DRB review September 16

TEP proposed Substation at 3210 & 3255 S Cottonwood Lane

Case numbers SE-22-35 (T22SE00035)

Proposed TEP Substation

Parcel 119-18-030A Topography (with aerial)

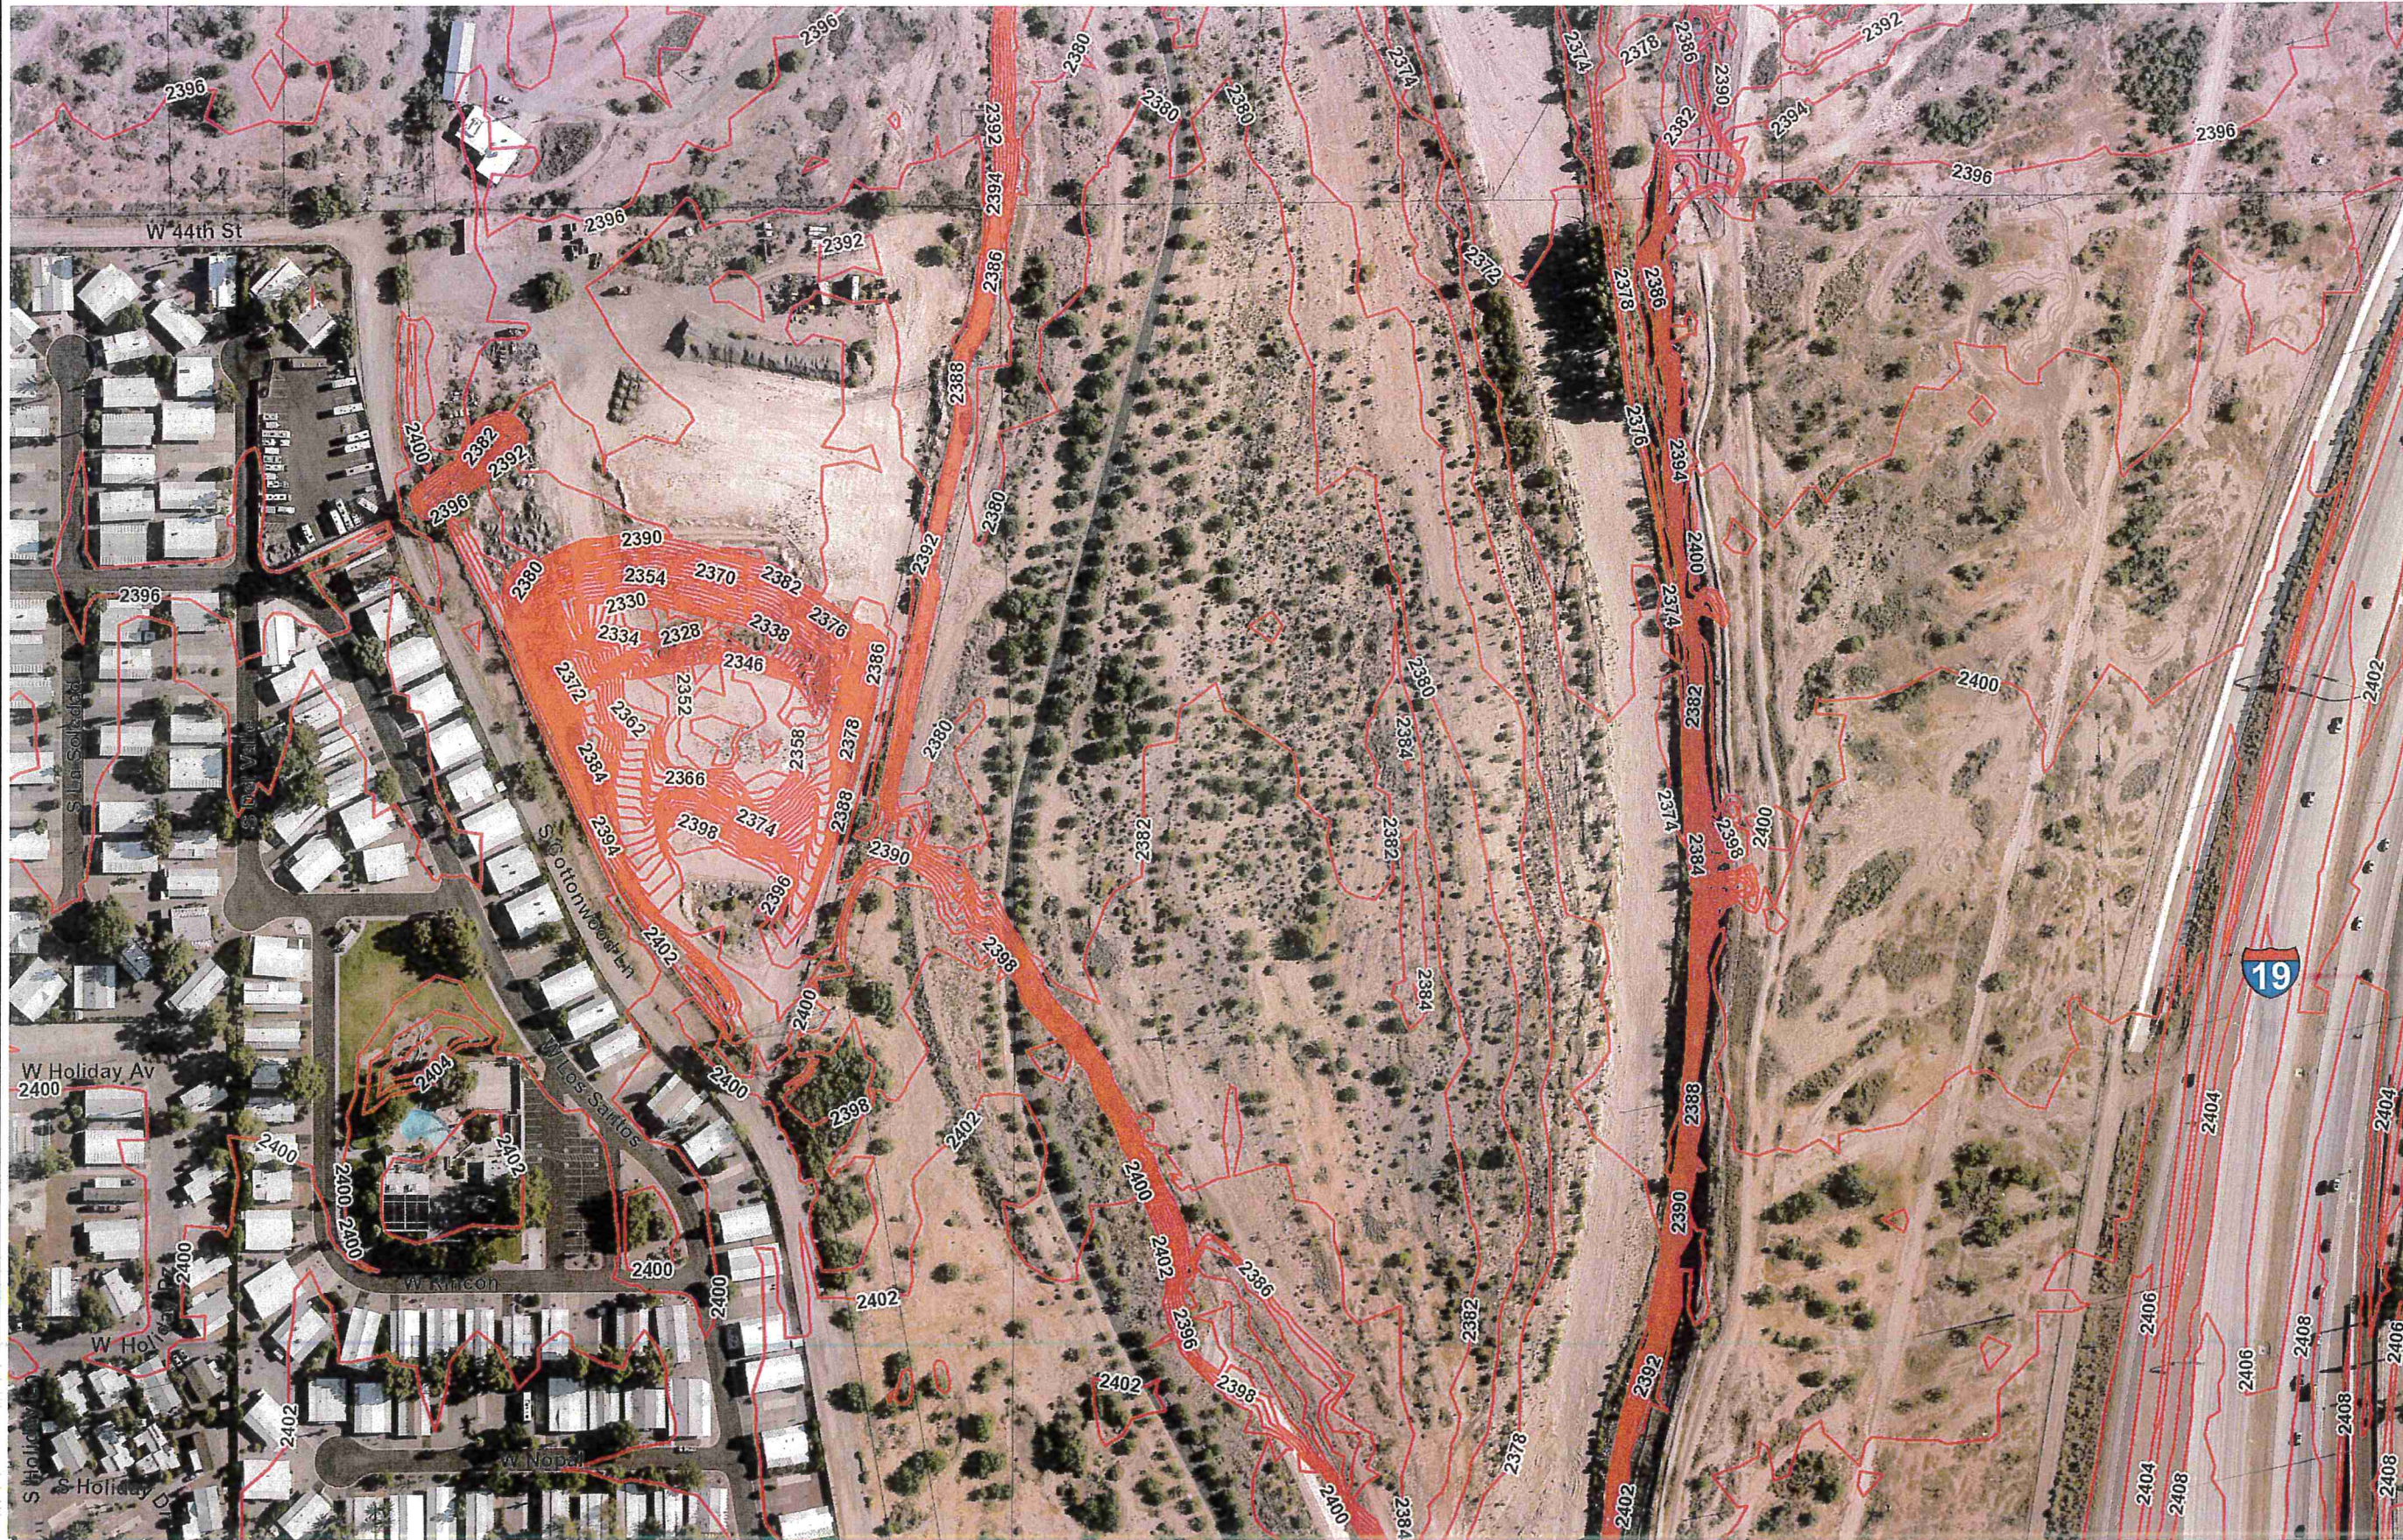
1. Decades-long history of a meandering river, flooding, and erosion to the site (see maps provided).
2. Santa Cruz River curved section and 30-degree angle of floodplain to the site are not in the Engineering Analysis used for the variance request to reduce the Erosion Hazard Setback (see topography maps).

Figure 20. Aerial Photograph (1936)

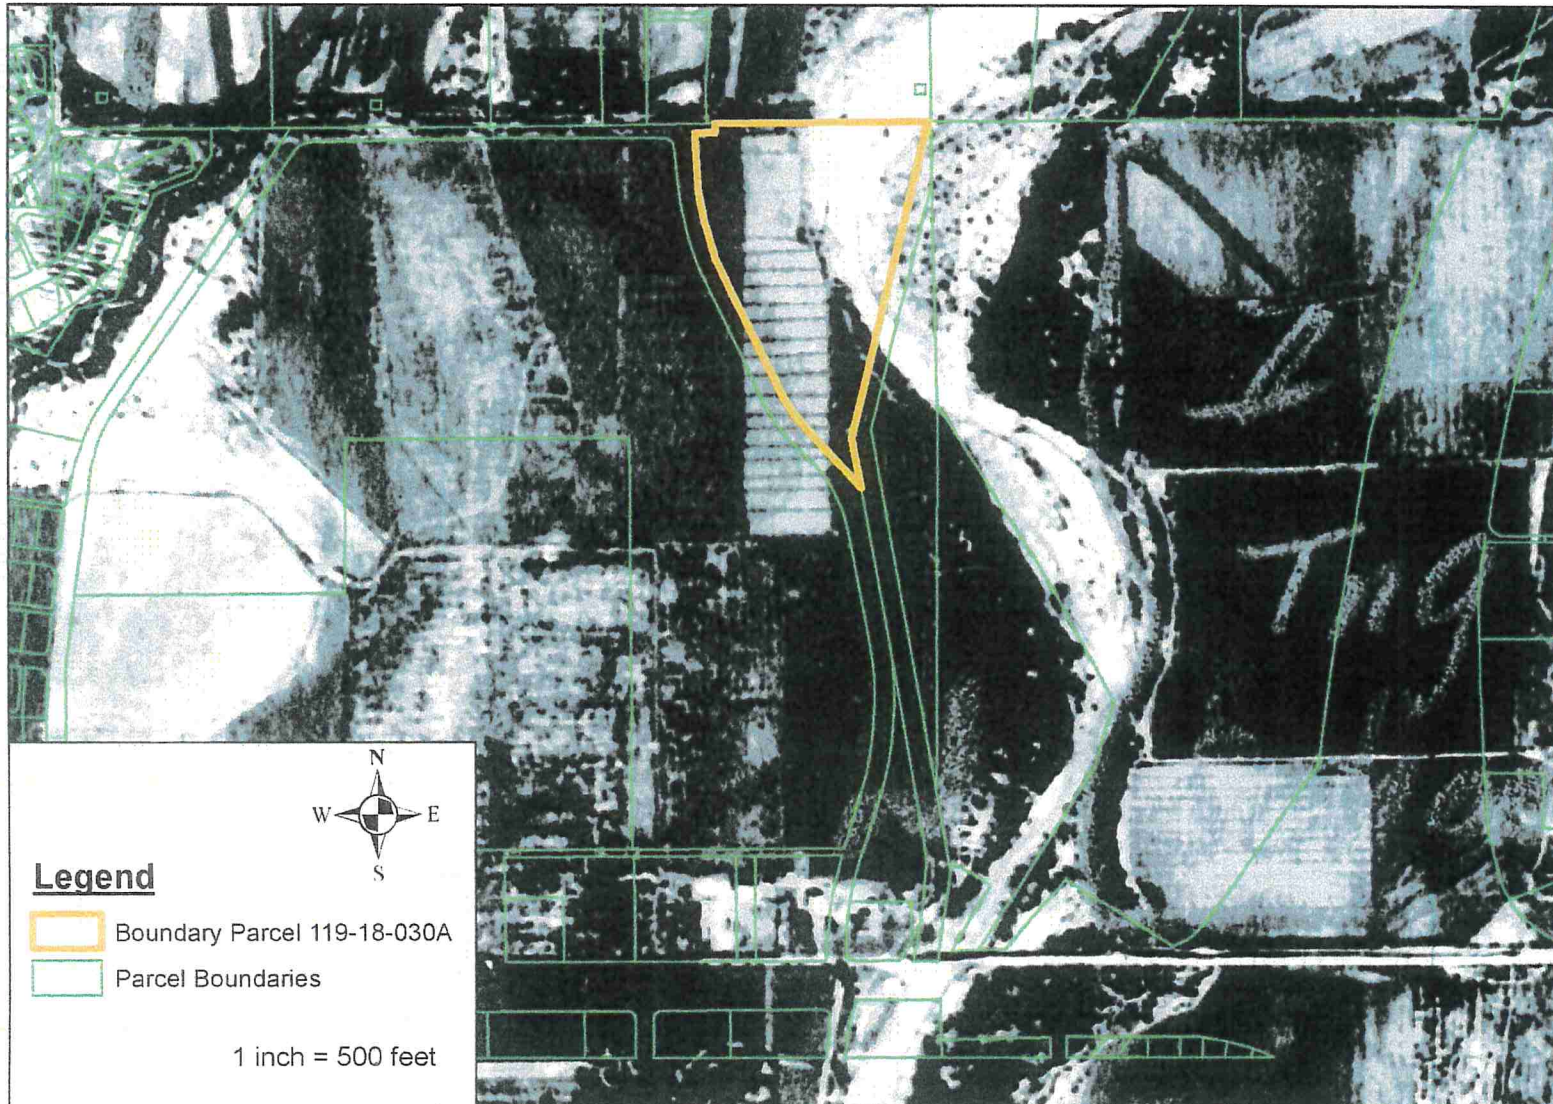
We emphasize that historically the proposed site is subject to channel widening and meandering of the Santa Cruz River. A future substation at this site would be impacted by erosion and flooding, resulting in emergency
